66319D-09

S E R V I C E N O T E

66319D - Mobile Communication Dual-Output DC Source,
With Battery Emulation, DVM. GPIB.

**Power-On Self test Errors, Auto reboot, Blank display. No output Communication errors.
No communication when using the GPIB Interface.**

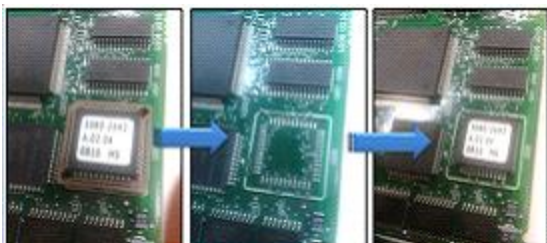
When the EEPROM is installed in the PLCC SOCKET (**Circuit Reference U205**) on the Interface board if there is not a gas tight connection between the EEPROM pins and the socket pins an intermittent connection will occur.

It has been determined when removing the socket and soldering the EEPROM (circuit reference U205) directly on the interface assembly “A2” would be very difficult (See Picture below), even having the correct tools, removal of the socket and replacement of the EEPROM is very difficult and may cause additional quality and reliability issues.

1. The problem can be solved by replacing the GPIB Interface assembly. See above for the tested interface P/N that is required to repair the instrument. The correct tested assembly for the specific model must be used when repairing a defective instrument.
2. This problem can also be solved by removing the socket (circuit reference U205) on the “A2” interface assembly and soldering the **Original** EEPROM directly to the Printed Circuit assembly.
